ZACHRY-MONTEREY REQUEST FOR INFORMATION ADDISON AIRPORT TUNNEL - JOB #9080.01 RFI# 140

Subject: **Bore for Bleiscend Conduit on Addition Road** Reply Req'd By: **08/26/97**

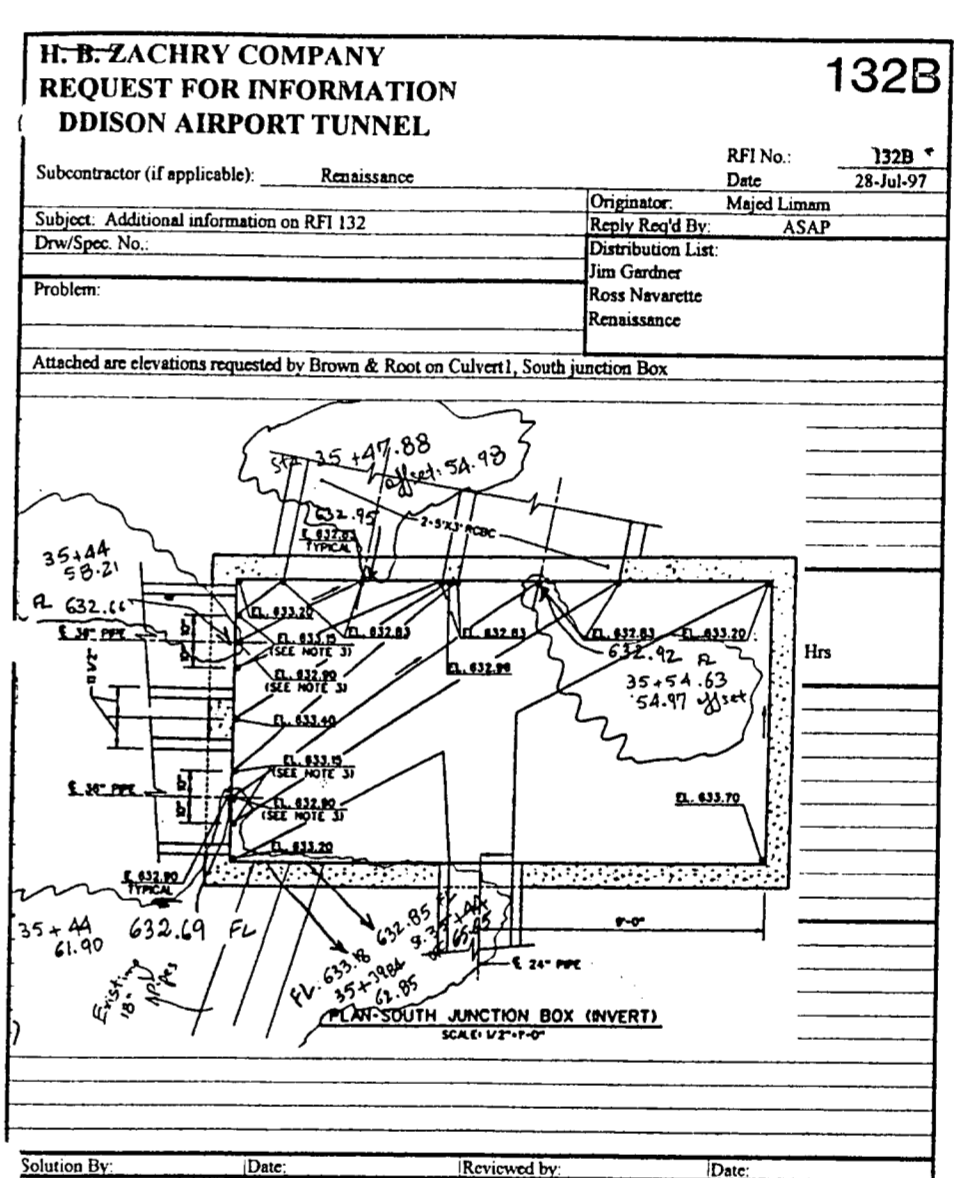
Problem: **Two 18" existing storm drains not shown in the Contract Drawings. One line appears to drain the area over the drainage and the other drains the parking lot area on the project. Please locate any manholes existing on these 2 lines of 18" RCP storm sewer within the trench and of Culvert. 1. Number of the lines of pipe is shown on the Contract Drawings. One line appears to drain the area over the drainage and the other drains the parking lot area on the project. Please locate any manholes existing on these 2 lines of 18" RCP storm sewer within the trench and of Culvert.**

Response by Construction Management: **The storm drains will be located. The storm drains will be located. The storm drains will be located.**
